Review of the Prudency and Efficiency of Aurizon Network's Proposed UT5 Maintenance Expenditure

Queensland Competition Authority

15 November 2017

Figure 2 - Ballast-cleaning production rates from Aurizon Network's UT5 Maintenance Allowance presentation

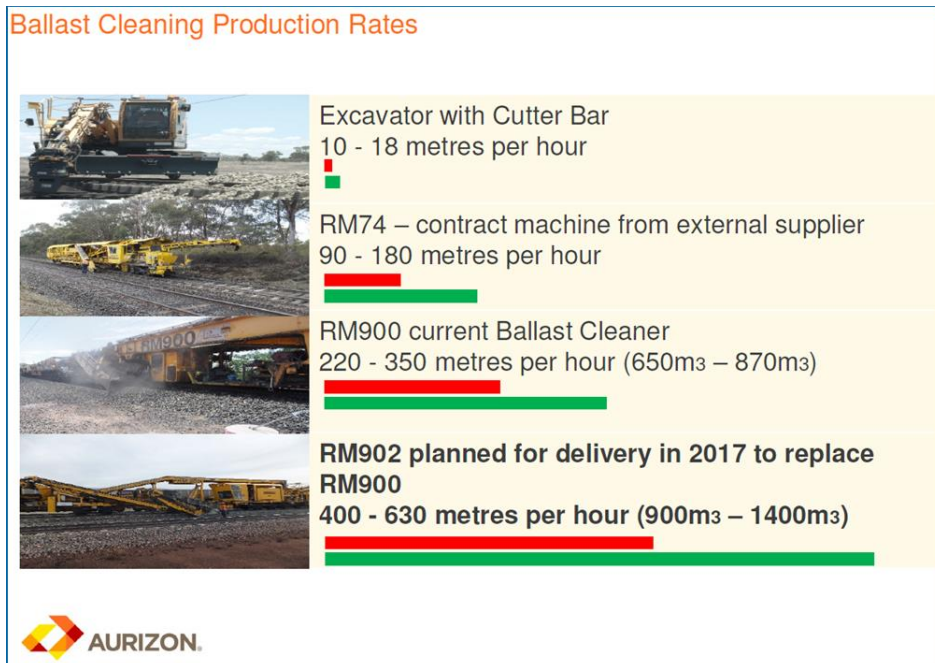
⁴² We note that Figure 2 says that Aurizon Network will take delivery of the RM902 in 2017. This is incorrect; it is supposed to be FY2019, as per page 169 of the UT5 submission to the QCA.

Figure 5 – Aurizon Network actual resurfacing time allocations

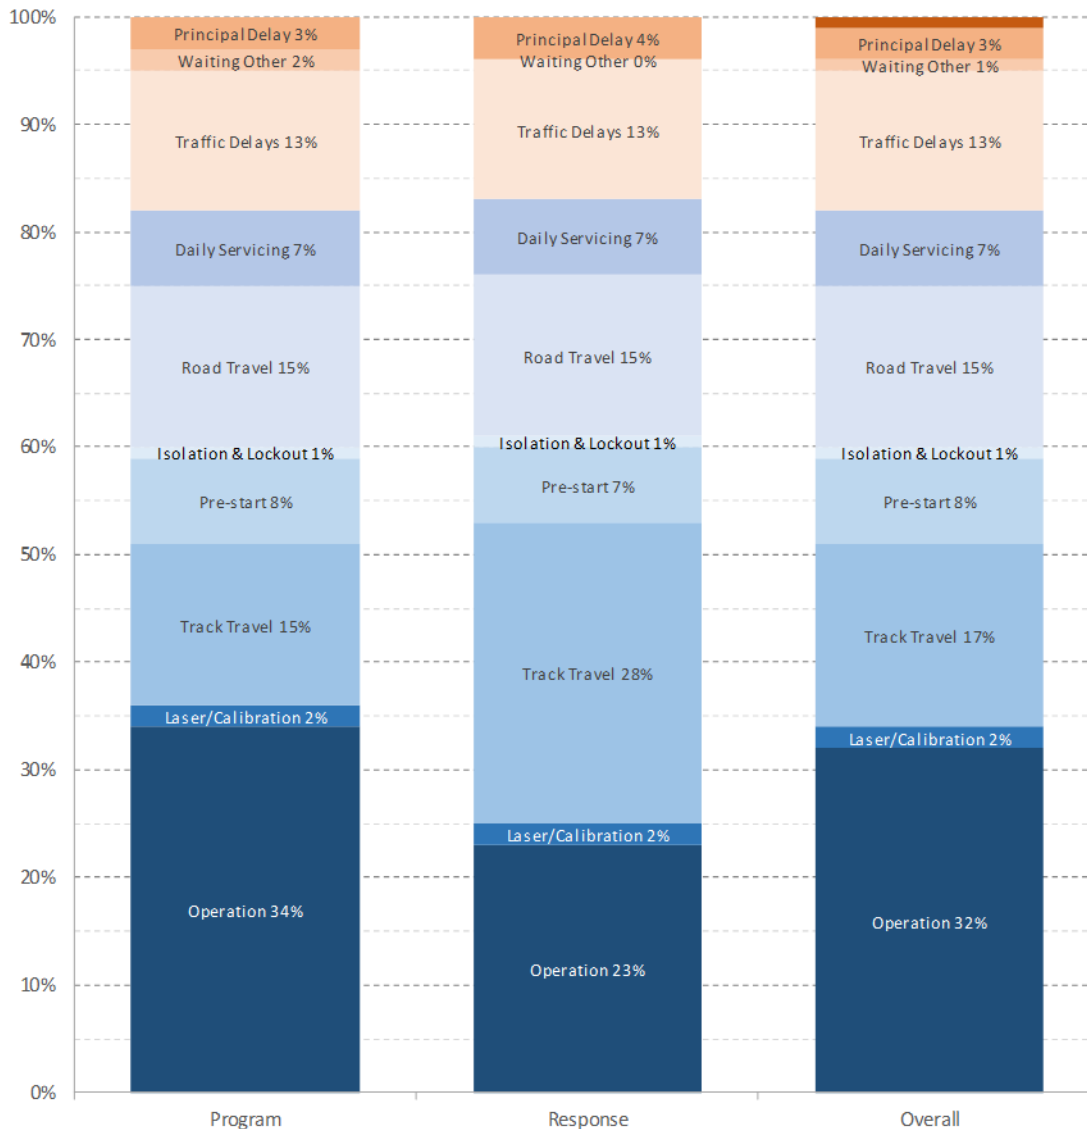
Aurizon Network considers all of the activities shown in blue shading as productive, and those in red shades as non-productive. The overall average time considered by Aurizon Network to be productive is approximately 83%.

Aurizon Network's productive use of a shift is 182 minutes / 570 minutes = 32.0 %. In comparison, our proposed figure is 254 minutes / 570 minutes = 44.6%.
